ADDENDUM No. 2

ITB No. 4569 Wheeler Service Center PUD Non-Motorized Improvements - Phase 2

Plans; replace originally issued bid plan set noted as "WCWRC Comments" (sheets 1 thru 14) dated 03-09-18 with that issued for "Addendum 2" (sheets 1 thru 14) dated 03-28-19. Revisions are noted below.

SHEET No. 10 OF 14

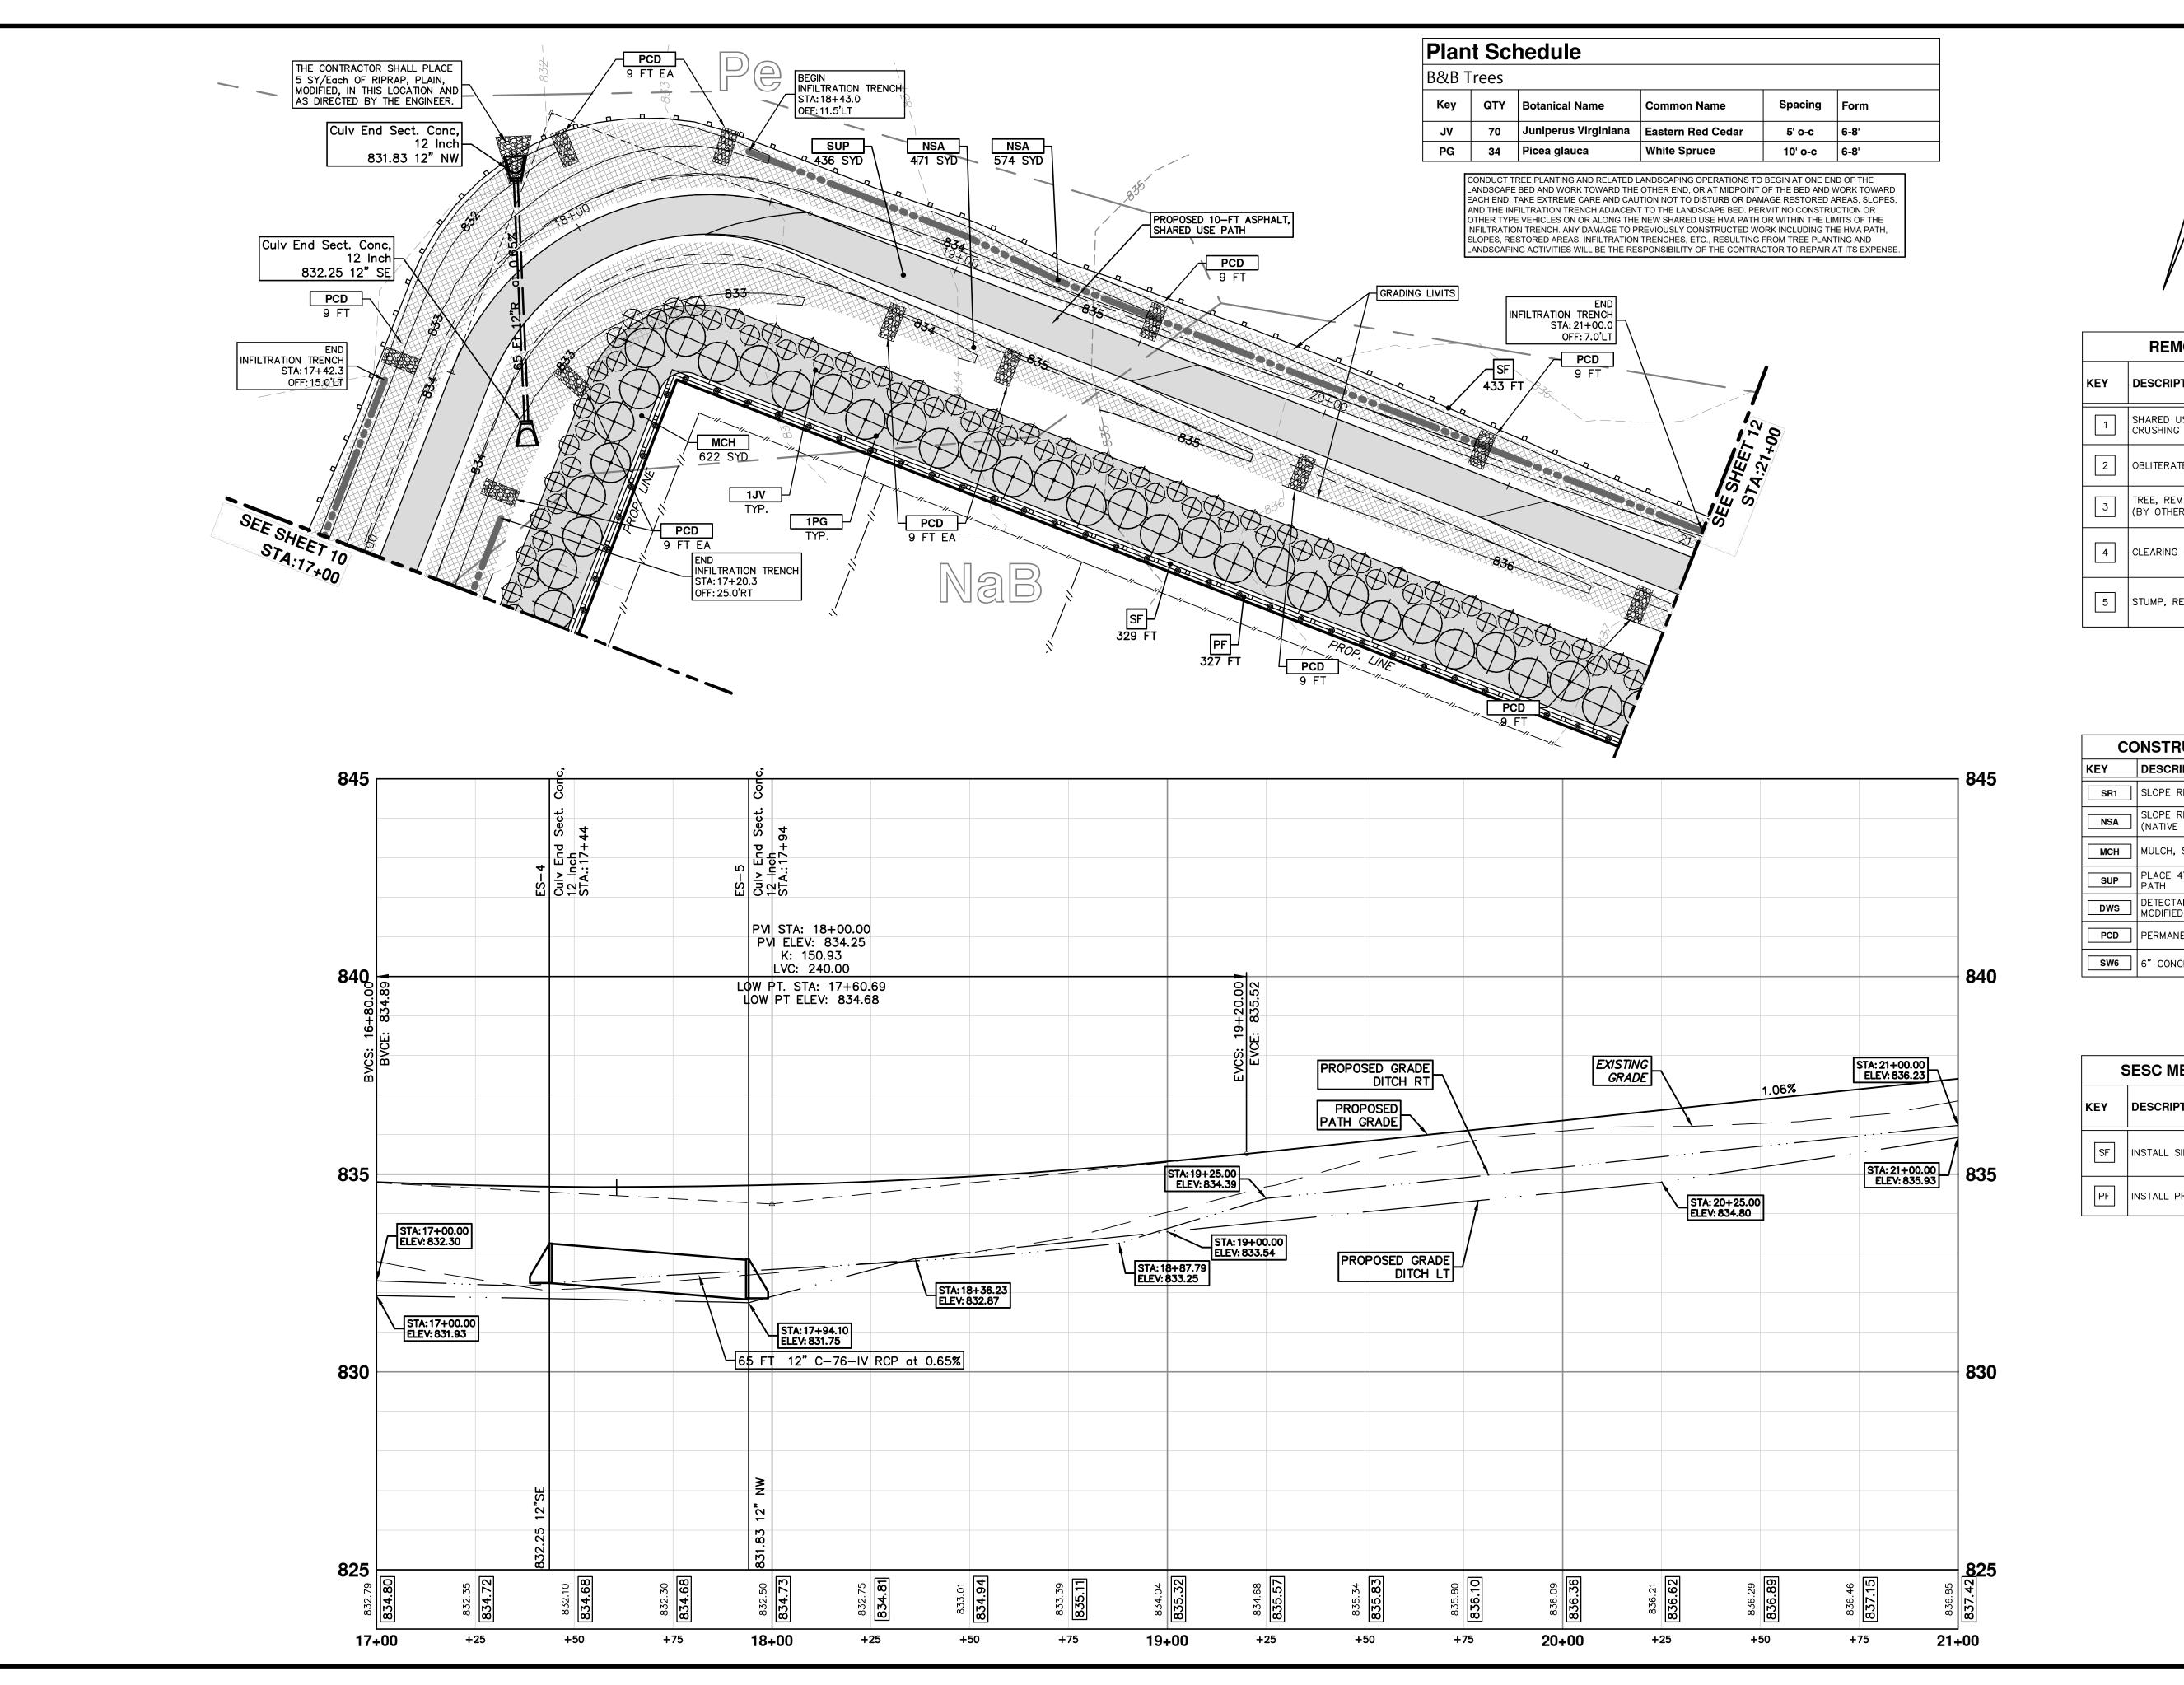
Removed protective fencing along the easterly limits of the construction area and revised callouts and quantities related to this work. Revised Removal, Construction, and SESC Measures Keys. Added note related to tree planting/landscaping work.
